Notes.		
<p>0 Site plan amended to confirm 12 parking spaces as the approval</p> <p>C AC Condenser compound shown. Refer to the supporting specifications</p> <p>B Landscaping notes for the discharge of the planning condition</p> <p>A Tree notes, waste recycling/storage and communal garden area shown following case officer post committee comments</p>		
Project:		
KEEPERS COTTAGE PROPOSED BOUTIQUE HOTEL		
Client:		
FORTIS HOSPITALITY SOLUTIONS (GLOBAL) LTD		
Drawing title:		
LANDSCAPING PLAN (TO SUPPLEMENT THE SITE PLAN)		
Status:		
Scale:		
1:100 AT A1		
Drawn by:	Checked:	PH
Date:		
6 January 2025		
Project no.	Fig. no.	Rev.
PHA/750	7000	D

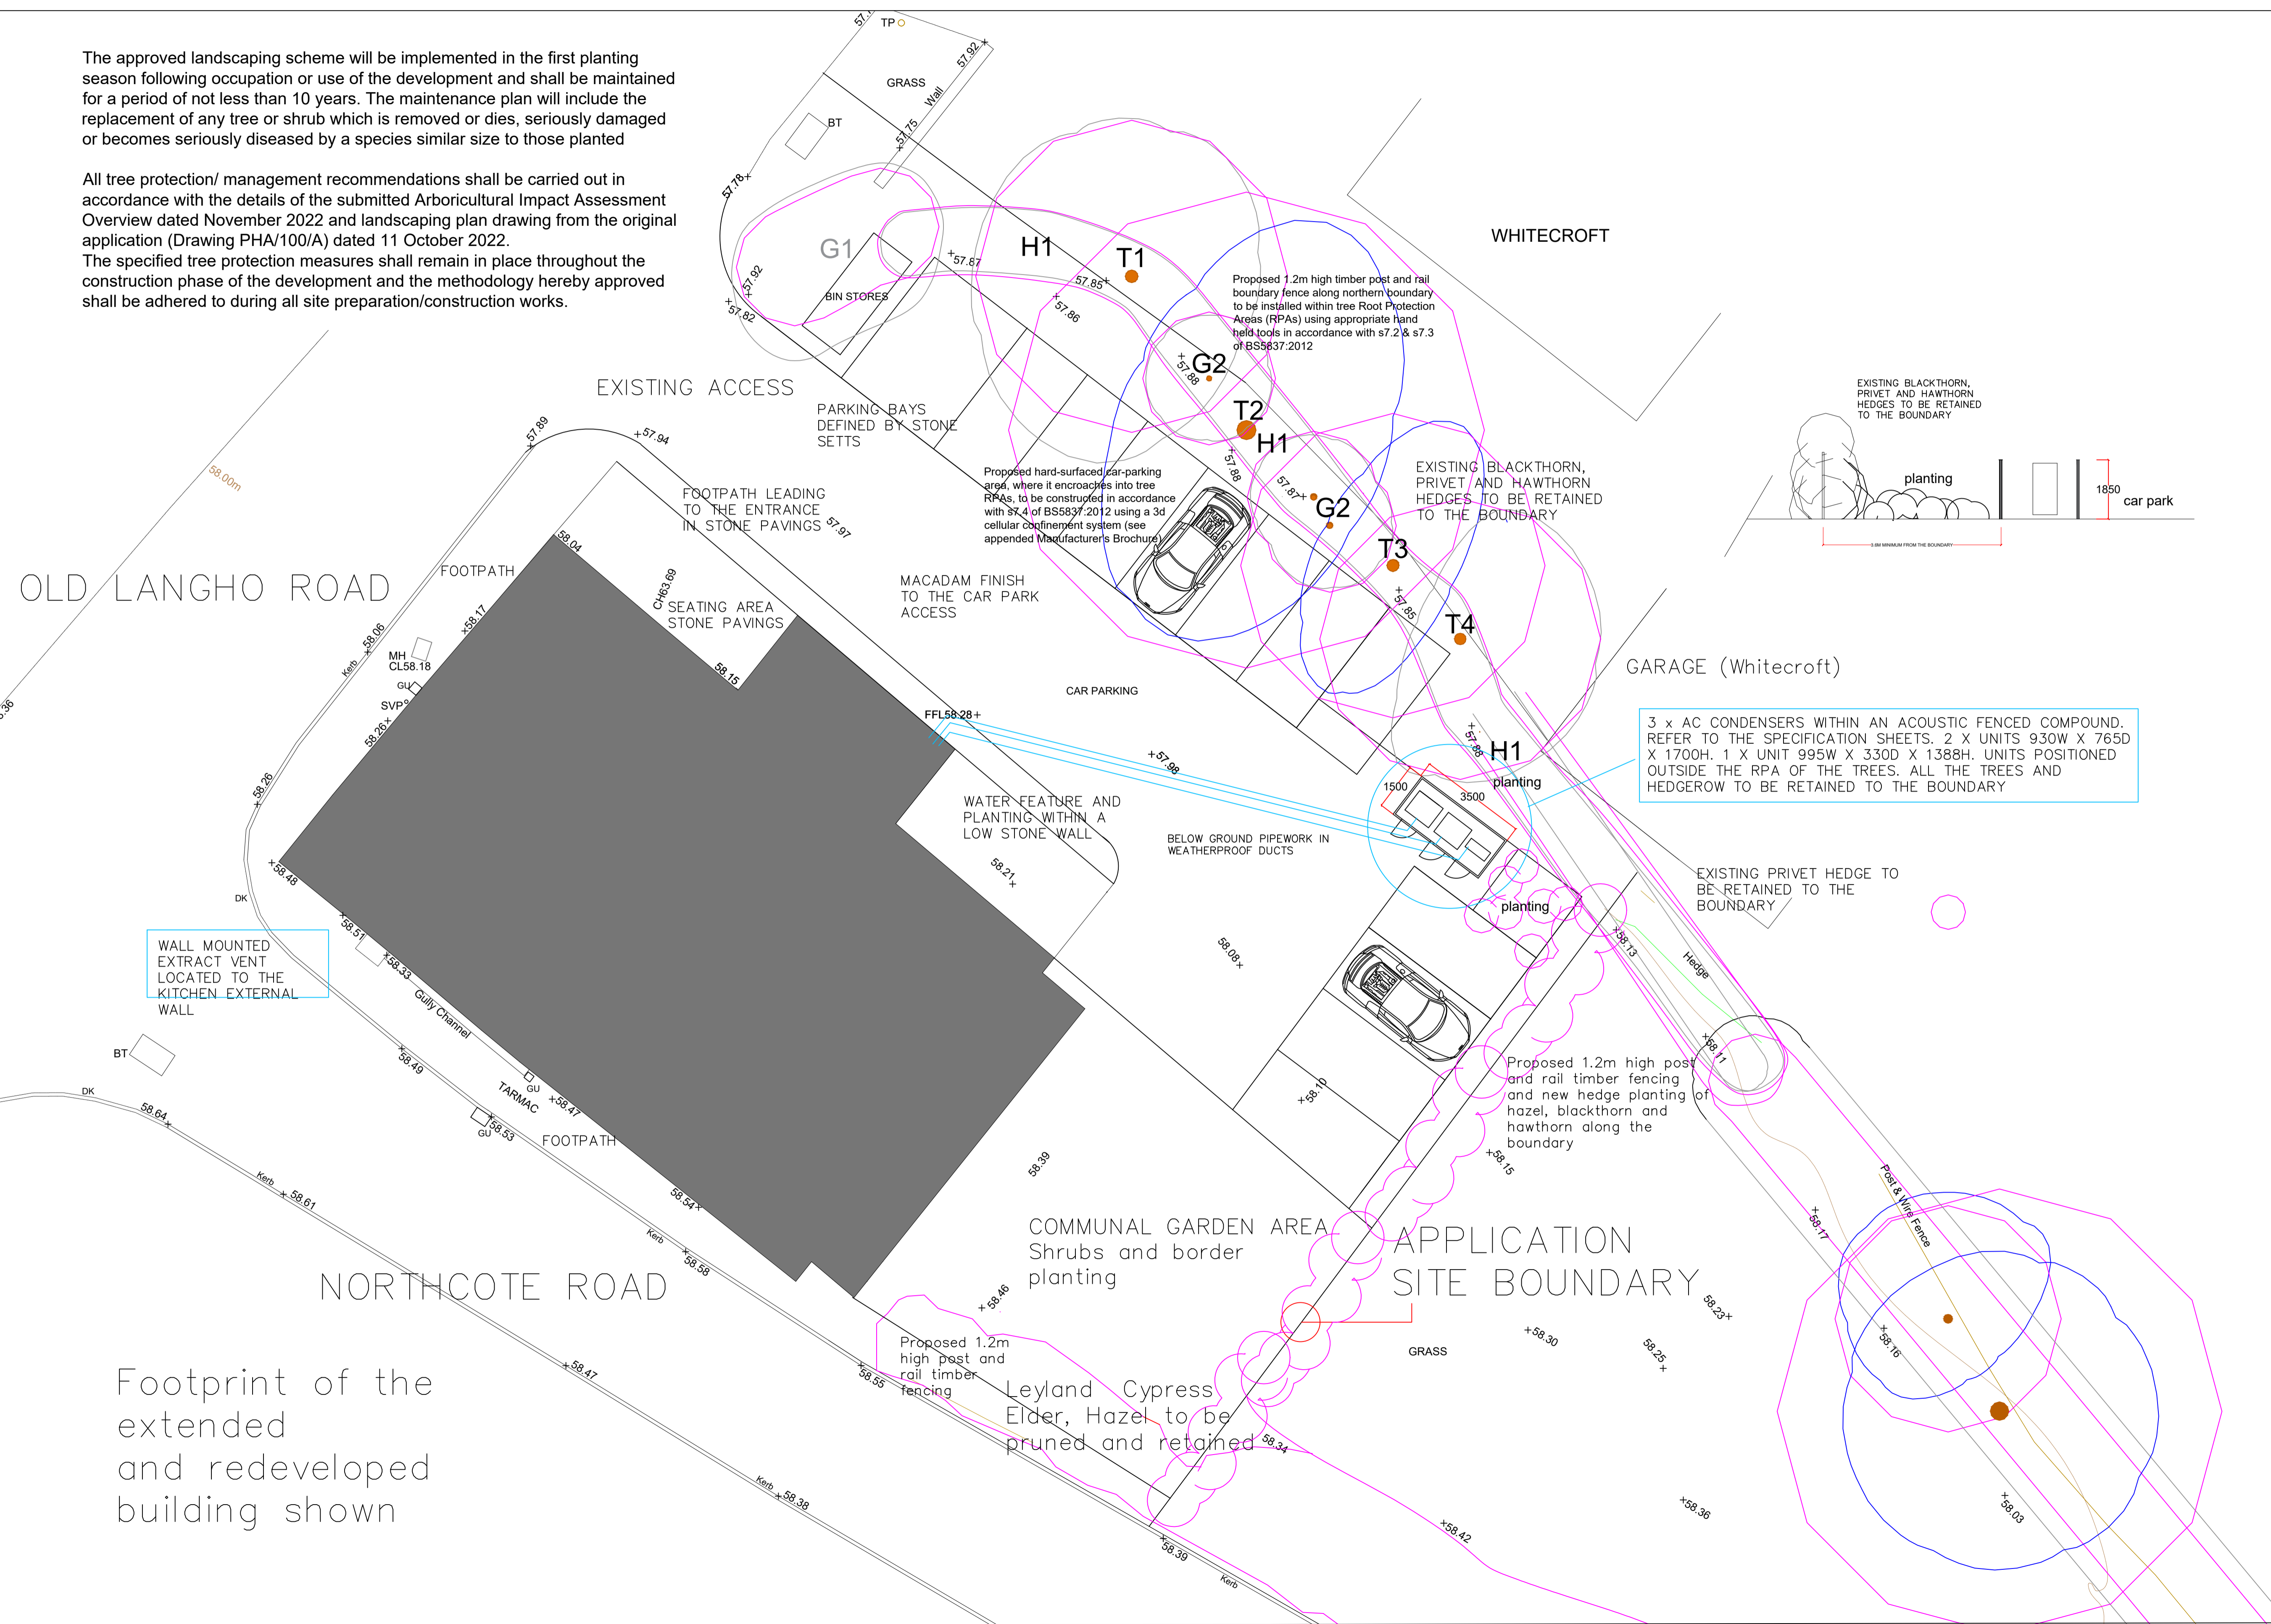
3 x AC CONDENSERS WITHIN AN ACOUSTIC FENCED COMPOUND. REFER TO THE SPECIFICATION SHEETS. 2 X UNITS 930W X 765D X 1700H. 1 X UNIT 995W X 330D X 1388H. UNITS POSITIONED OUTSIDE THE RPA OF THE TREES. ALL THE TREES AND HEDGEROW TO BE RETAINED TO THE BOUNDARY
